SPECIFICATION

NAME	BATTERY HOLDER: 3259		
SCALE	1.5:1	APPD	
UNIT	MM	CHKD	
MAT'L	AS SPEC.	DWN	CHENGZHENHUA
DATE	OCT. 31. 1999	DR NO	4111P14-1099

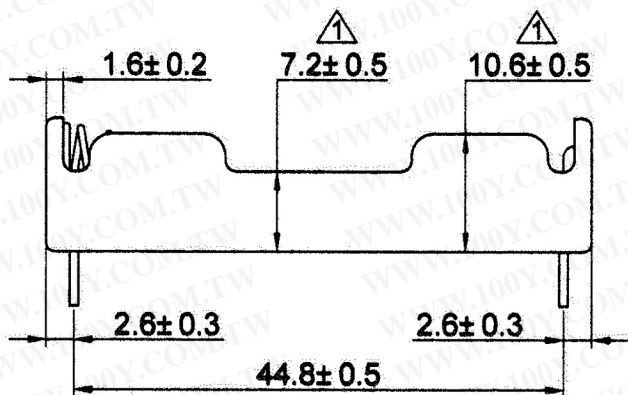
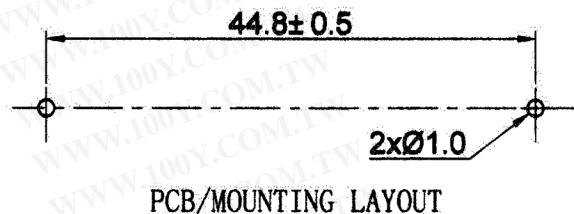
△	changed wire output from round to square added a inside radius to R1.0	Apr/03/2009
▲	Changed dimension from 11.1 to 10.8, 7.0 to 7.2, 7.5 to 8.0, 1.2 to 1.0	Mar/19/2009
NO.	MODIFICATION	DATE
<p>THIRD ANGLE PROJECTION</p>
